## Planning and Land Use Committee Report For the Meeting of May 28, 2015

**Subject:** **Development Permit with Variances Application No. 000409 for 370 and 384 Harbour Road**

**DOCKSIDE GREEN - AFFORDABLE HOUSING**  
 370 & 384 HARBOUR ROAD, VICTORIA  
 778-744-4444  
 11/1/2015

Figure 1; Locations of Baseline Noise Monitoring Sites 1, 2 and 3 (Tyee Road to the left and Harbour Road to the right).

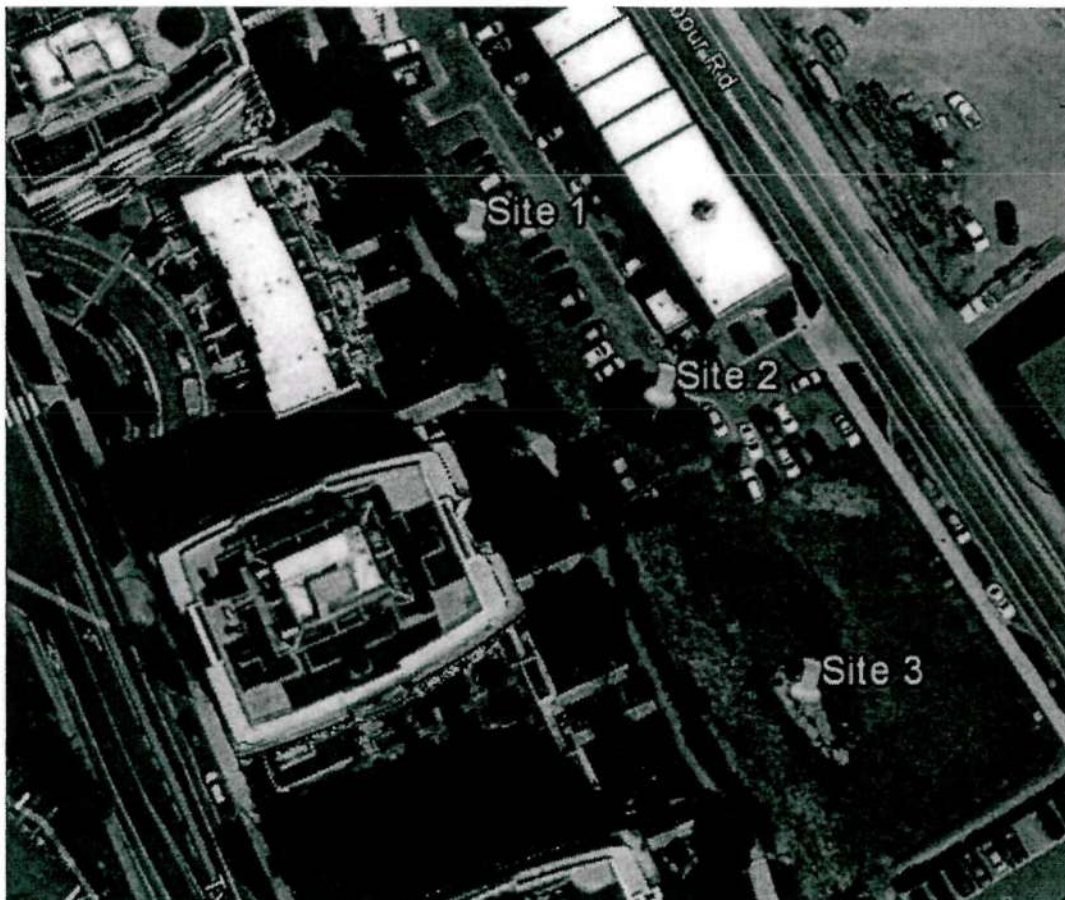
Wakefield Acoustics Ltd. (WAL) conducted baseline noise monitoring over a 48-hour period at three locations (see Figure 1) from October 22 to 24, 2014. This monitoring has shown that current daily average noise exposures were  $L_{eq}(48)$  54.9 dBA at monitoring Site 1 (representing the northern half of building R4), 53.5 dBA at Site 2 (representing the southern end of building R4), and 51.9 dBA at Site 3 representing building (R5).
